Access Compliance Report

Public Rights-of-Way

(Curb Ramps)

Intersection ID: 10024336	Main Street: CREEKRIDGE_RD	Cross Street: N/A	Location: NE
ADA ID: A1087C3A8E51	Ramp Type: Directional1	Initial Pass/Fail: Fail	Overall Compliance: No
		Severity Score: 12.5

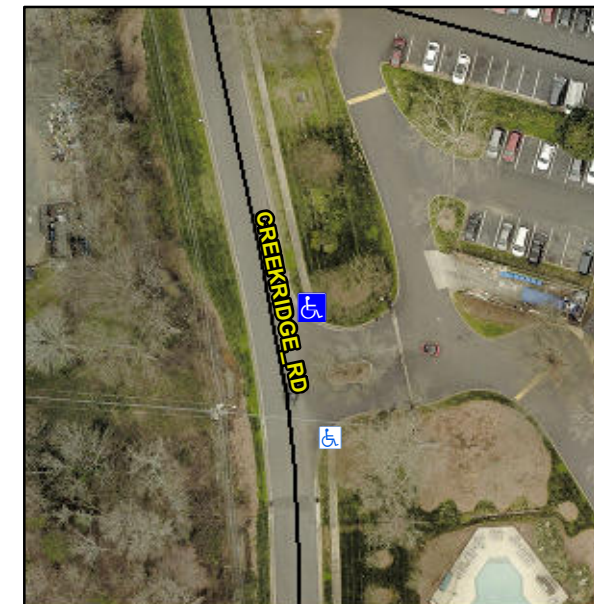
R304.5.3

Compliance	Description	Data	Compliance	Description	Data
N/A	Ramp Length (in)	83.0	N/A	Grade Break?	N/A
Yes	Ramp Width (in)	48.0	N/A	Grade Break Slope (%)	0.0
Yes	Ramp Slope (%)	3.1	N/A	Grade Break XSlope (%)	0.0
No	Ramp XSlope (%)	5.3			
N/A	Flare Type LT	N/A	N/A	Flare Type RT	N/A
N/A	Flare Slope LT (%)	N/A	N/A	Flare Slope RT (%)	0.0
N/A	Flare Traversable LT?	N/A	N/A	Flare Traversable RT?	N/A
N/A	Landing Length (in)	0.0	N/A	DWS Provided?	N/A
N/A	Landing Width (in)	0.0	N/A	DWS Contrast?	N/A
N/A	Landing Slope (%)	0.0	N/A	DWS Length (in)	N/A
N/A	Landing X Slope (%)	0.0	N/A	DWS Full Width?	N/A
N/A	Landing Curb? (Y/N)	N/A	N/A	DWS Offset LT (in)	N/A
N/A	Shared Landing?	N/A	N/A	DWS Offset RT (in)	N/A
N/A	Gutter Ponding?	0.0	N/A	Gutter Slope (%)	N/A
N/A	Gutter Lip Ht (in)	0.0	N/A	Gutter X Slope (%)	N/A
N/A	Painted X Walk1?	No		Road Slope (%)	0.2
	X Walk 1 Direction	To SW		Road X Slope (%)	1.9
	X Walk 1 Width (in)	N/A		Clear Space?	N/A

Remove & Replace Entire Ramp.
